**IEEE P802.11
Wireless LANs**

TGa November Comments Processed

Date: November 10, 1998

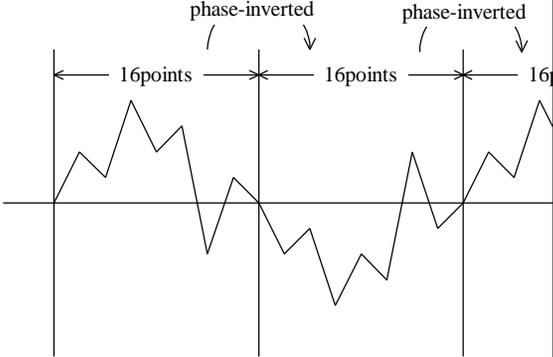
<p>Continued</p>	<p>in 1.3.8.3: The adjacent channel rejection shall be equal to or better than XX dB for 6 Mbit/s, XX dB for 9 Mbit/s, XX dB for 12 Mbit/s, XX dBm for 18 Mbit/s, XX dB for 24 Mbit/s, XX dB for 36 Mbit/s, XX dB for 48 Mbit/s and XX dB for 54 Mbit/s, with a PER of 10% at a MPDU length of 1000 bytes.</p> <p>in 1.3.8.4: The non-adjacent channel rejection shall be equal to or better than XX dB for 6 Mbit/s, XX dB for 9 Mbit/s, XX dB for 12 Mbit/s, XX dBm for 18 Mbit/s, XX dB for 24 Mbit/s, XX dB for 36 Mbit/s, XX dB for 48 Mbit/s and XX dB for 54 Mbit/s, with a PER of 10% at a MPDU length of 1000 bytes.</p> <p>in table 12, aPLCPHeaderLength: X μs (for 6 Mbit/s) X μs (for 9 Mbit/s) X μs (for 12 Mbit/s) etc.</p> <p>in table 12, aSupportedDataRatesTx and aSupportedDataRatesRx: 6, 9, 12, 18, 24, 36, 48, 54 Mbit/s</p> <p>in table 12, aMPDUDurationFactor: 4/3 (for 9, 18, 36, 54 Mbit/s)</p>
